MOOLARBEN COAL COMPLEX OC3 EXTENSION PROJECT

SUBMISSIONS REPORT

Figure 4-5

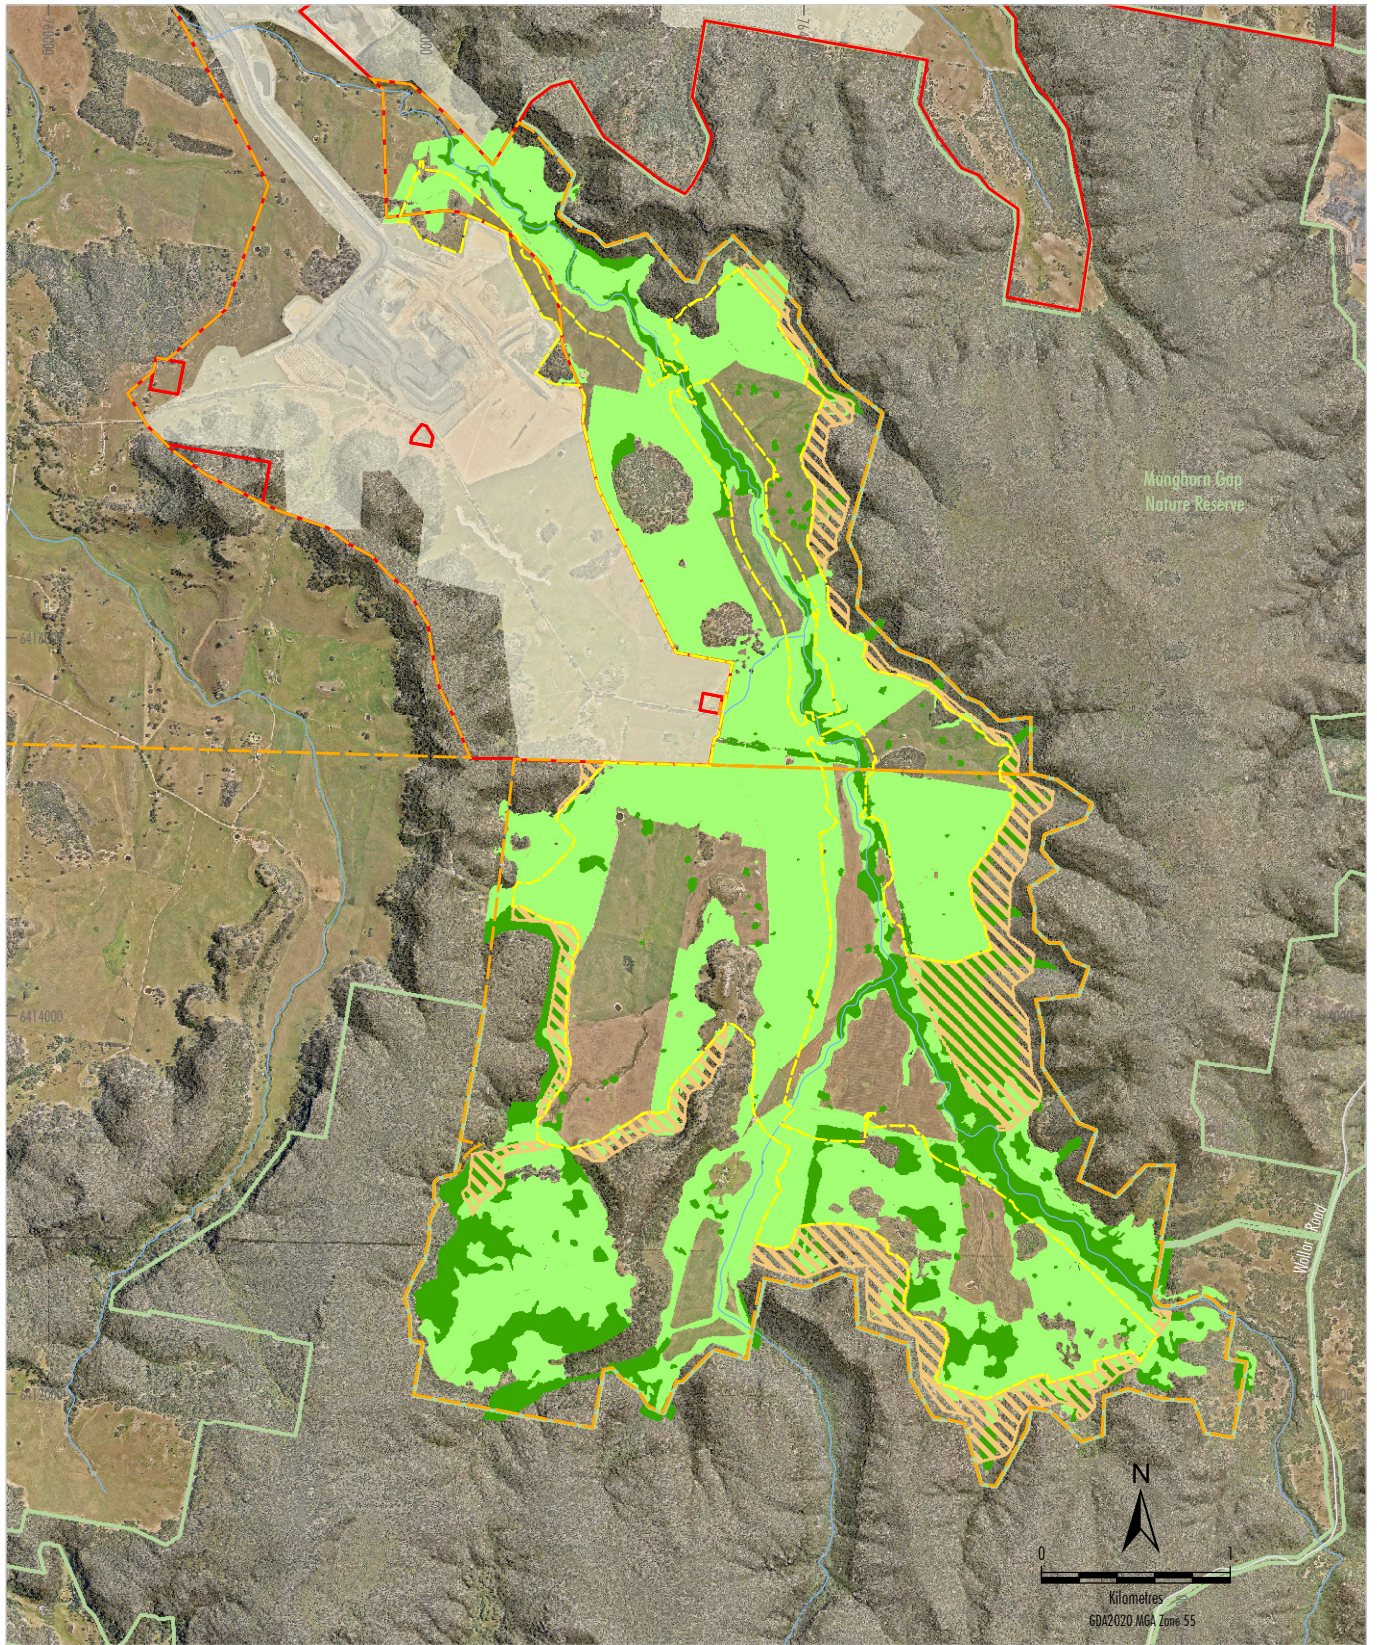
The consent authority note BCS advice in relation to SAIL criteria for Box Gum Woodland when considering the adequacy of avoidance and minimisation to biodiversity impacts proposed, conditioning of the project and potential project approval.

MCO has reviewed the Project design and reduced the indicative surface disturbance extent to avoid and/or minimise impacts to Box-Gum Woodland critically endangered ecological community (CEEC). In relation to the Box-Gum Woodland CEEC, the amended Project design achieves 59% reduction in disturbance of the woodland component of Box-Gum Woodland CEEC compared to the Project EIS, as shown in Figure 4-5.

Figure 4-6

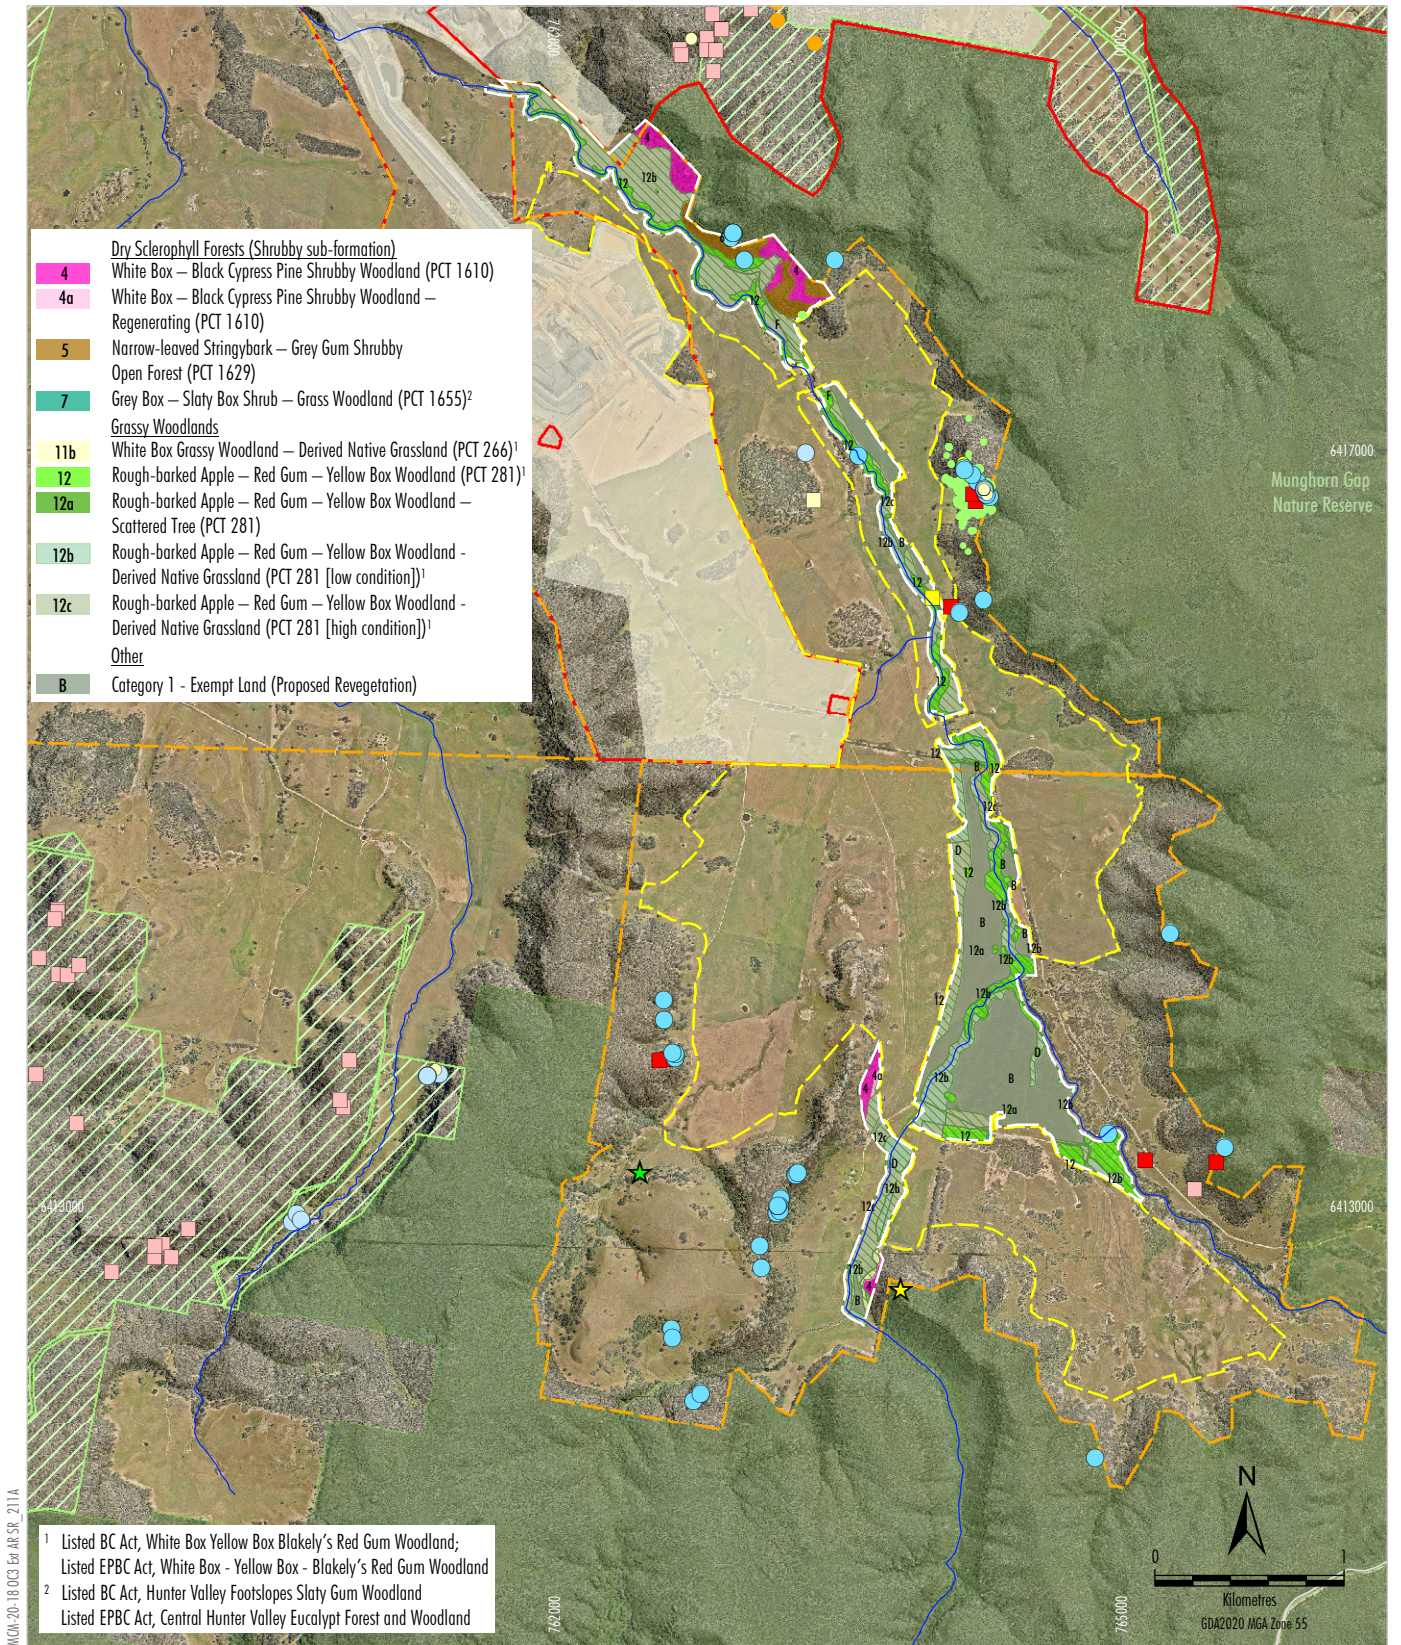
The proponent revise the currently presented development footprint and avoidance and minimisation strategies proposed to further reduce impacts to Box Gum Woodland.

MCO has reviewed the Project design and reduced the indicative surface disturbance extent to avoid and/or minimise impacts to Box-Gum Woodland CEEC. In relation to the Box-Gum Woodland CEEC, the amended Project design achieves 59% reduction in disturbance of the woodland component of Box-Gum Woodland CEEC compared to the Project EIS (Figure 4-6).

Figure 4-7

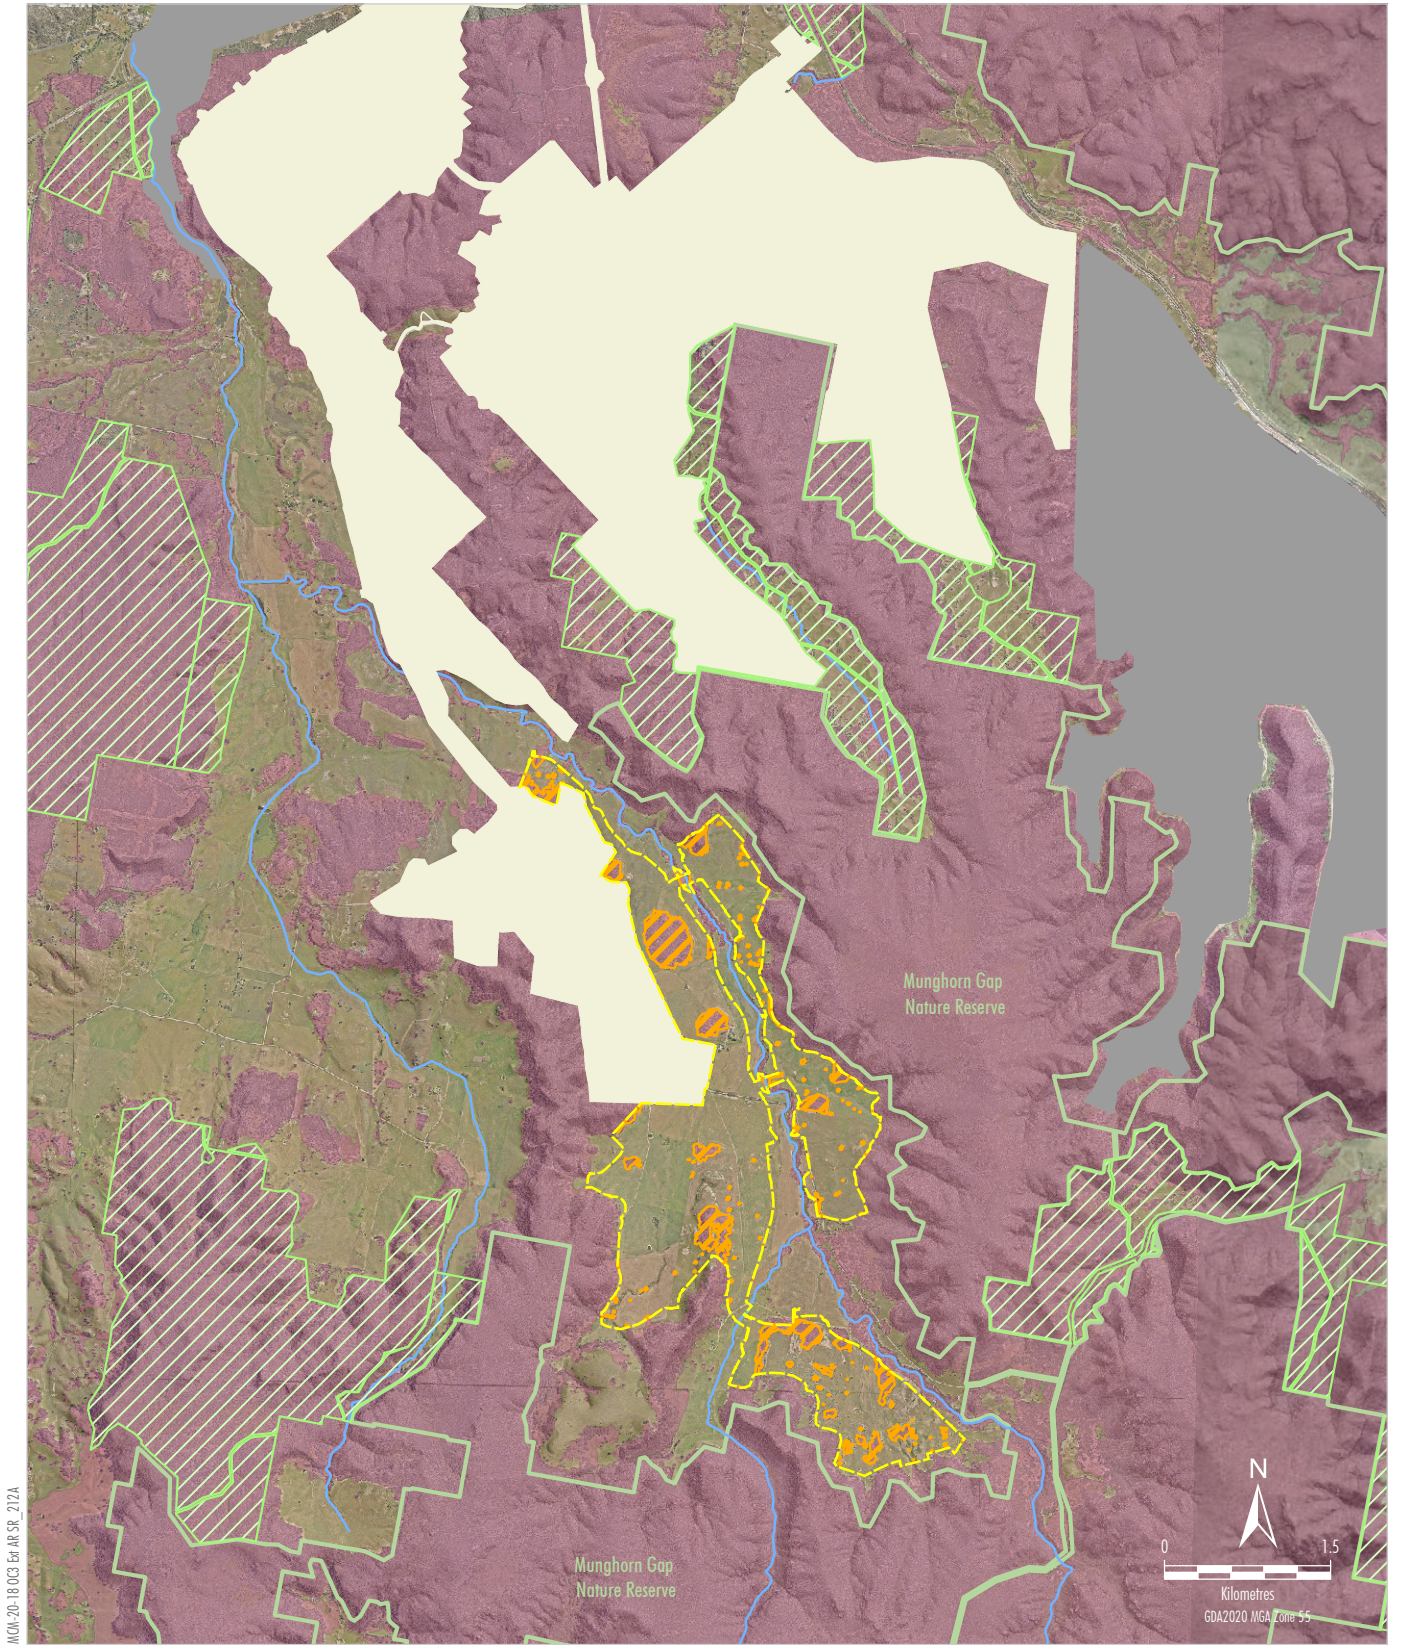
The consent authority note BCS advice in relation to SAI criteria for Regent Honeyeater when considering the adequacy of avoidance and minimisation to biodiversity impacts proposed, conditioning of the project and potential project approval.

The Project has been amended to avoid and/or minimise impacts to additional areas of threatened species habitat. In regard to the Regent Honeyeater, the amended Project design achieves 56% reduction in disturbance of Regent Honeyeater Important Habitat Mapping compared to the Project EIS as shown in Figure 4-7.

The Project has been amended to avoid and/or minimise impacts to additional areas of threatened species habitat. In regard to the Regent Honeyeater, the amended Project design achieves 56% reduction in disturbance of Regent Honeyeater Important Habitat Mapping compared to the Project EIS as shown in Figure 4-7.

Figure 4-9: Residual Drawdown and Mounding at End of Recovery Period (Source: AGE, 2024)

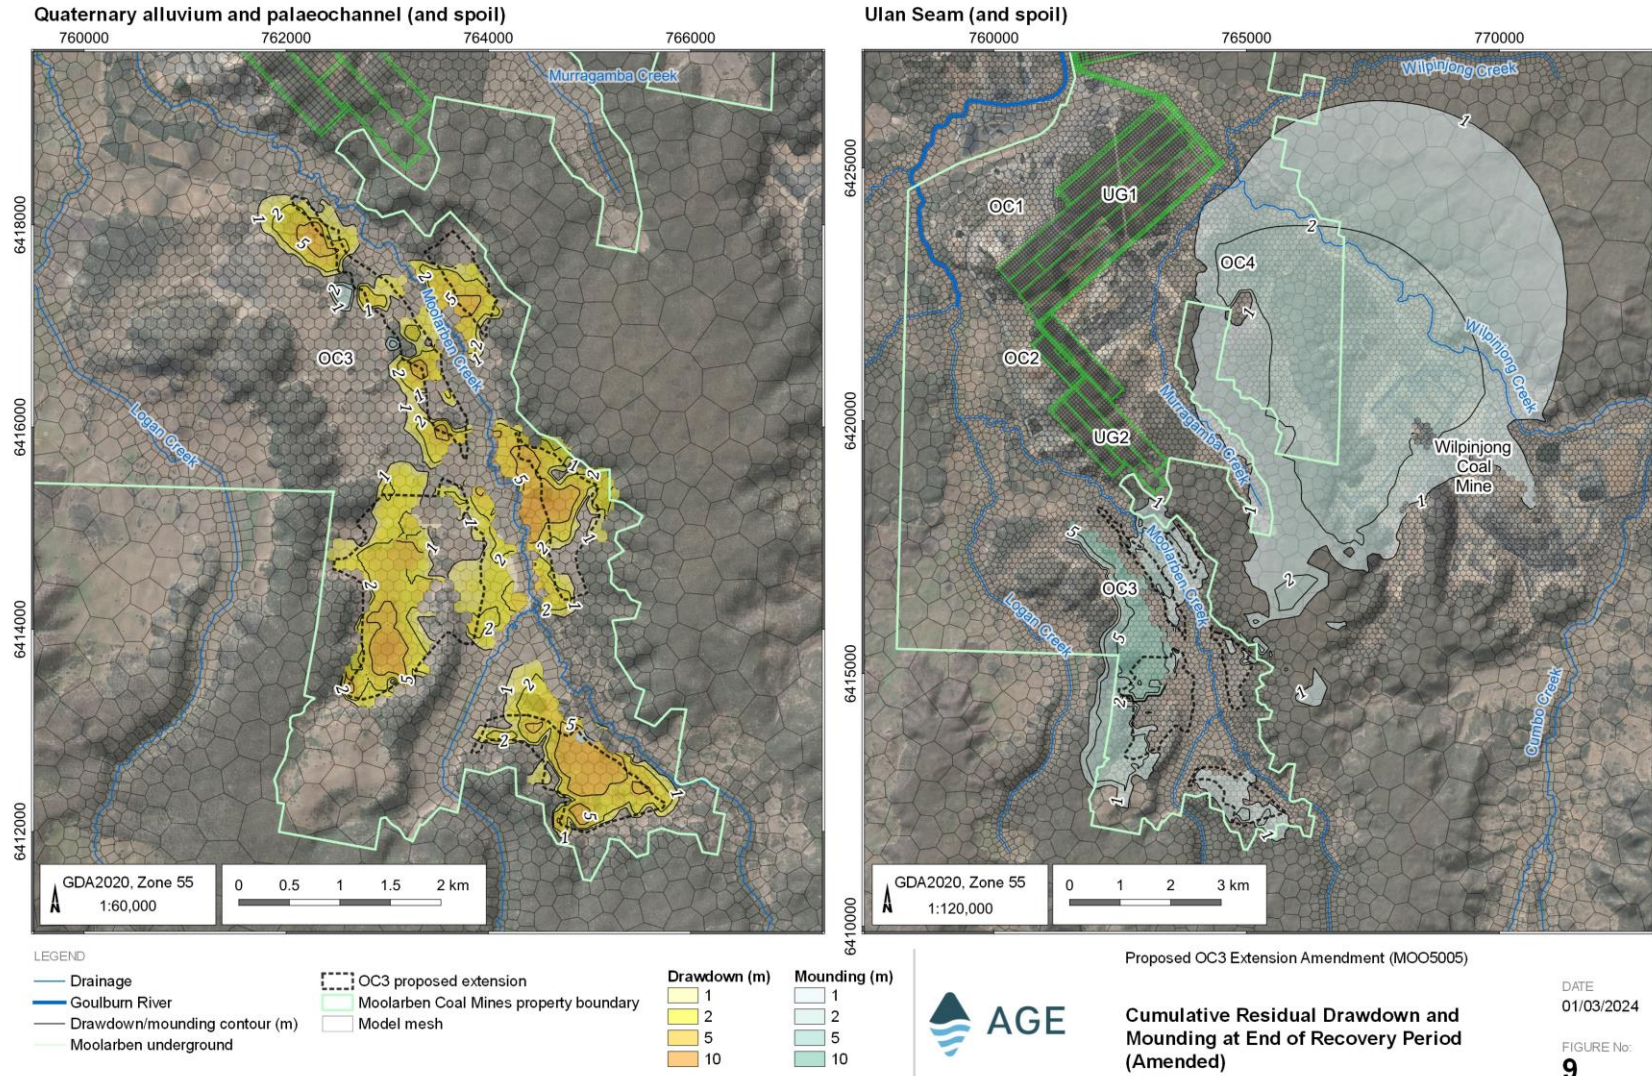
12. *It is predicted that mounding would start approximately 30 years after operations have ceased and will stabilise around 470 m AHD somewhere in the middle of the predictive period (refer to AGE 2022, Figure 5.6, p. 99). The proponent should discuss potential adverse impacts (e.g., waterlogging) of the predicted mounding to the health and persistence of GDEs and riparian vegetation.*

AGE (2024) has updated the groundwater modelling undertaken for the amended Project, and there is limited overlap between areas of predicted mounding of the groundwater table and GDEs and riparian vegetation (outside of the surface development for the Project), with a maximum of 2 m of mounding predicted within the Quaternary alluvium and paleochannel aquifers at the potential terrestrial GDEs and riparian vegetation (Figure 4-9).
